Regarding: Essroc San Juan Cement  
Compliance Evaluation Inspection, June 7, 2012 and Consent Decree (3:09-cv-01578)  
Individual Permit No. PR0001163 and MSGP 2008 Tracking No. PRR05BJ45  
Site visit: June 7, 2012  
Inspector: Murray Lantner, PE Environmental Engineer USEPA Region 2

The present letter responds to and clarifies the comments you raised as a result of your inspection performed of the stormwater conveyance systems at the Essroc site on June 7, 2012. Due to more than twelve (12) months of continuous compliance with applicable requirements, this letter is also intended to demonstrate our interest in terminating the Consent Order based on ESSROC's satisfactorily compliance with the requirements for termination under the Consent Decree.

The following photos show how efficient the system is working, with rocks installed in bottom of channel, and the Gabions keyed at the channels walls:

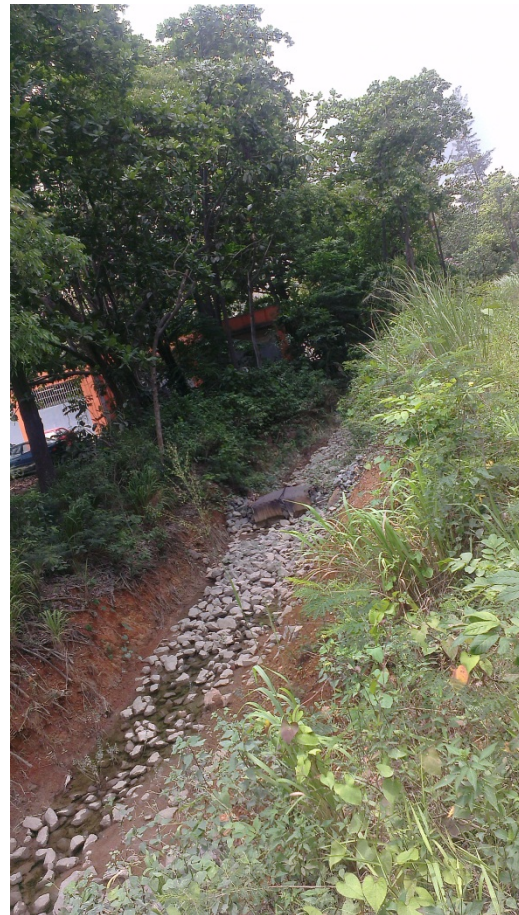
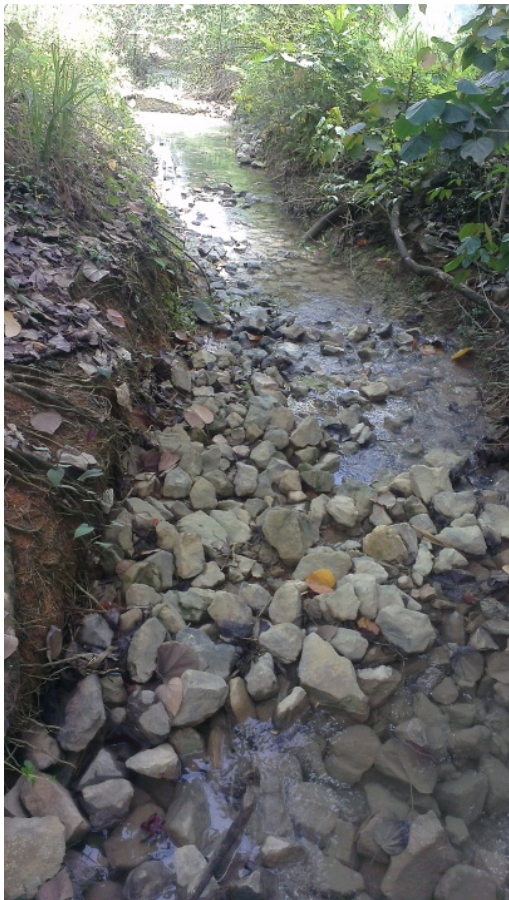
**Paragraph 12.b.i required that the Lagoon Enhancement System be capable of treating the 10 year 24 hour storm. In addition to failing to properly operate and maintain the Lagoon Enhancement System, based upon the findings above, the system does not appear to be design to in accordance with Paragraph 12.b.i of the CD. Essroc must conduct upgrades to the Lagoon Enhancement System to ensure that the water does not flow around the gabions and that the channel is vegetated as required.**

Essroc refurbished the gabion system in December 2012 during which time the bottom of the channel was filled with rocks and new gabions were installed. This was performed to ensure that water does not flow around the gabions. Thus, Essroc has been complying with the EPA requirements and has upgraded the system to further ascertain its proper performance. Report and design of the Stormwater Consolidation Proposal and conveyance system upgrade was included in Quarterly Report send on January 28<sup>th</sup> 2013.
